30-015-27453-00-S1

EOG PROPOSES TO PLUG AND ABANDON THIS WELL USING THE ATTACHED PROCEDURE.

**** BLM REVISED ** BLM REVISED ** BLM REVISED ** BLM REVISED ** BLM REVISED ****

Poker Lake Fed 18 #1 – P&A

Current Wellbore Diagram:

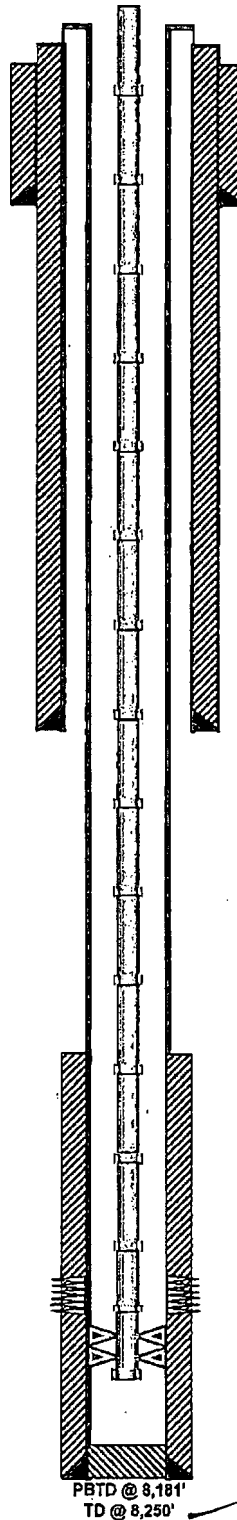
3. Set 5.5" CIBP at 7,874'.
4. Tag CIBP, circulate plugging mud and spot 25 sx Class H on top of CIBP; WOC & Tag. (180' min.)
5. Pick up, spot a 25 sx class C cement plug from 6,500' – ~~6,400'~~ 6340 (160' min)

6. Pick up, perf @ 4,325' and sqz a 30 sx class C cement plug to ~~4,214'~~ 4185, WOC & Tag.
7. Pick up, perf @ 4,105' and sqz a 780 sx class C cement plug to ~~865'~~ 710 in accordance to R-111-P. 710

8. Pick up, perf @ 515' and sqz a 25 sx class C cement plug to 415'; WOC & Tag. WOC Tag.
9. Pick up, perf @ 100' and sqz a 25 sx class C cement plug to surface.

The well is outside R-111-P, but in the Secretary's Footash, Solid Plug is not required.

7. Perf @ 4105, sqz cnt to 3965. WOC Tag. Can Combine w/ #6.
- Perf @ 810, sqz cnt to 710. WOC Tag. Can Combine w/ #8.

SQZD CSG Leak @ 4'485 - 4,516' ?

6200

760

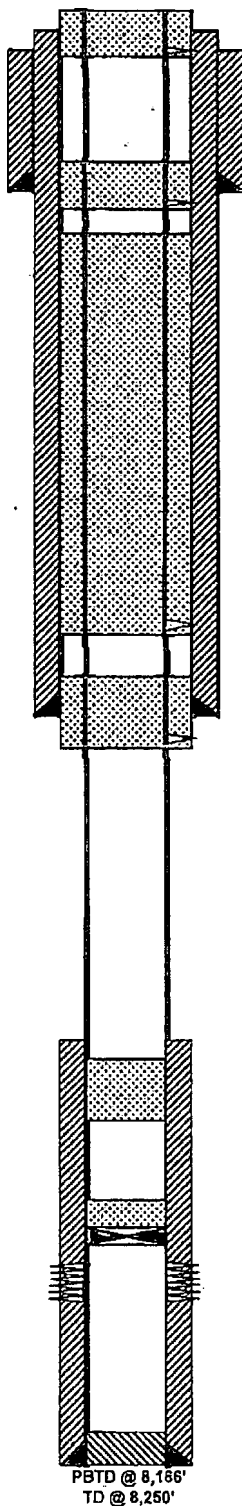
Perf @ 100' & sqz 25 sx class C cmt to surface

Perf @ 515' & sqz 25 sx class C cmt to 415' WOC & Tag

Perf @ 4,105' & sqz 780 sx class C cmt to 885'

Perf @ 4,325' & sqz 30 sx class C cmt to 4,214' WOC & Tag

Spot 25 sx class C cmt plug @ 6,500 - 6,400'

Set CIBP w/ 25 sx class H cmt @ 7,874' WOC & Tag
